14-0906-RR-FED

Re: In the matter of the authorization of Wheeling & Lake Erie Railway to install active grade crossing warning devices in Huron and Richland Counties

Diagnostic Review Team Survey

Field Dimensions

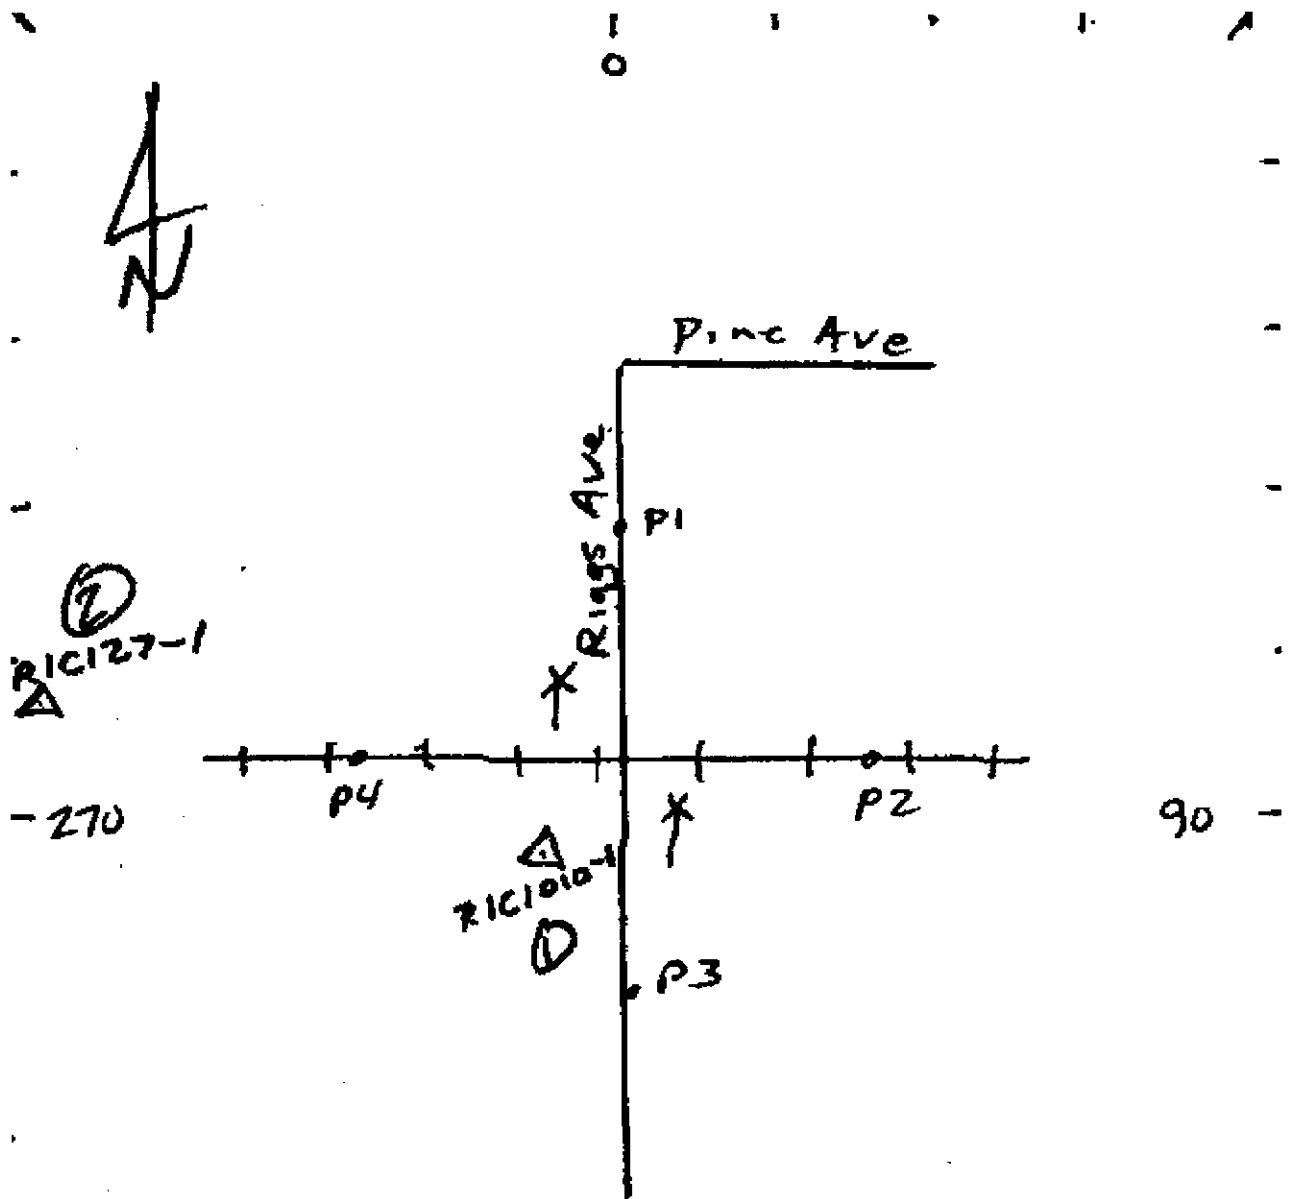
Extend Small Culverts on both sides.

Diamond West of Crossing

Quadrants Needed
☒ Install/upgrade active devices	
☐ Automatic Flashing Lights (AFLS)	
☐ AFLS / Cants	
☒ AFLS / Gates	SE & NW
☐ AFLS / Gates / Cants	
☐ Bells / number	
☐ Upgrade circuitry / type	
☐ Sidelights	
☐ Guardrail Needed	
☐ Install/Replace curb	
☐ Bungalow placement & offset from rail & highway	
☐ Other (define)	
Comments:	
☐ Install/upgrade traffic signal preemption	
☐ No improvements needed	
☐ Other (define)	
Acknowledgement of Recommendations (each entity represented at the diagnostic must have at least one signature acknowledgement):  Dan REINSEI  Guy Mark

Field Dimensions

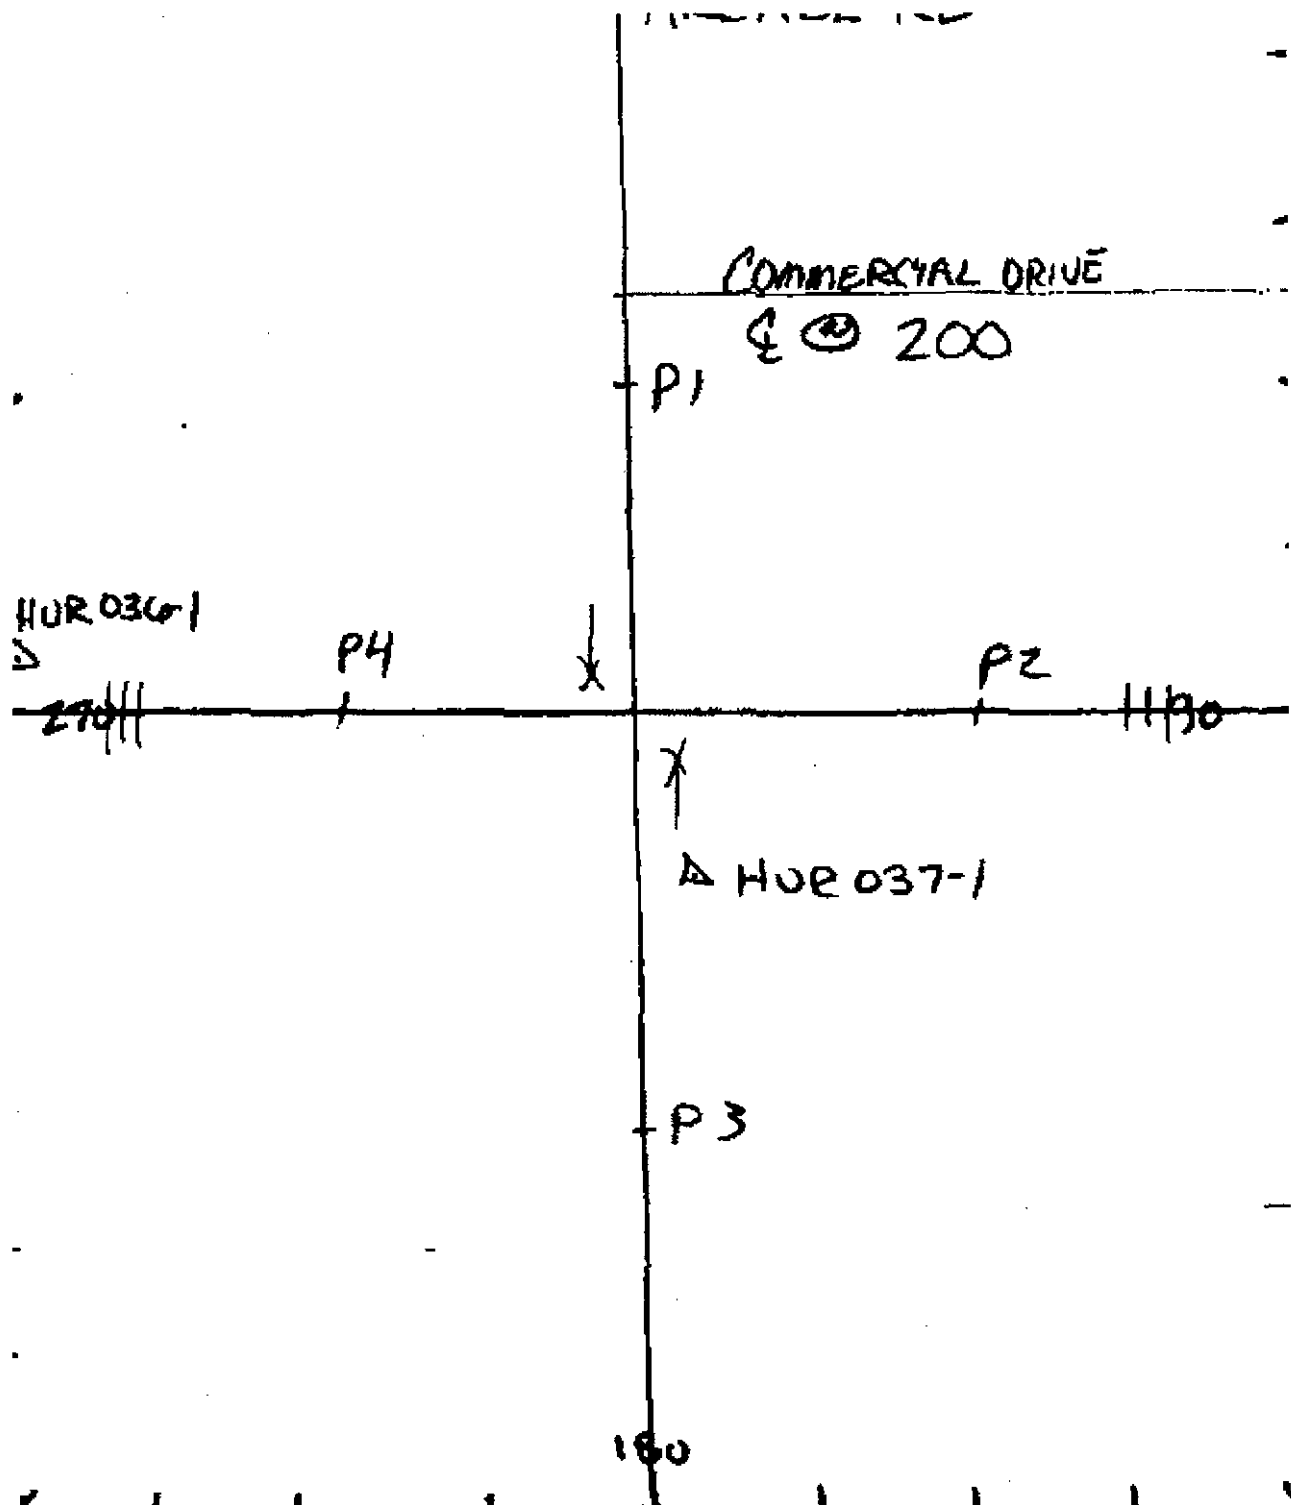
Is it the consensus of the Diagnostic Review Team that this is a potential closure project? ☒ No ☐ Yes Explain reasons: _____	
Type of Development	
☒ Open Space ☐ Industrial ☒ Residential	☐ Institutional ☒ Commercial Location of nearby schools: _____
Utility Information	
Is commercial power available? ☐ No ☒ Yes Utility Provider (Company Name) _____ Phone Number _____ Nearest Available Power Source _____	
What other utilities are present? (add locations to sketch) ☐ Gas ☒ Cable ☒ Telephone ☐ Fiber Optic Cable ☐ Petroleum ☐ Water ☐ Sanitary Sewer ☐ Other _____	
Is(are) there potential utility conflict(s) ☐ Yes ☐ No ☒ Unknown	
Comments: <u>Overhead telephone / TV cable lines need raised.</u>

Sidewalks outside signals.

Diagnostic Team Recommendations	
	Quadrants Needed
☒ Install/upgrade active devices	
☐ Automatic Flashing Lights (AFLS)	
XXXXXXXXXX	
☒ AFLS / Gates	NW
☒ AFLS / Gates / Cants	SE
☒ Bells / number	TWO
☐ Upgrade circuitry / type	
☒ Sidelights	Total 3 / 1 No Left Turn Flashers
☐ Guardrail Needed	
☐ Install/Replace curb	
☐ Bungalow placement & offset from rail & highway	
☐ Other (define)	
Comments: Design PE w/ all new flashing signals as in the field with the addition of roadway gates	
☐ Install/upgrade traffic signal preemption	
☐ No improvements needed	
☐ Other (define)	
Acknowledgement of Recommendations (each entity represented at the diagnostic must have at least one signature acknowledgement):
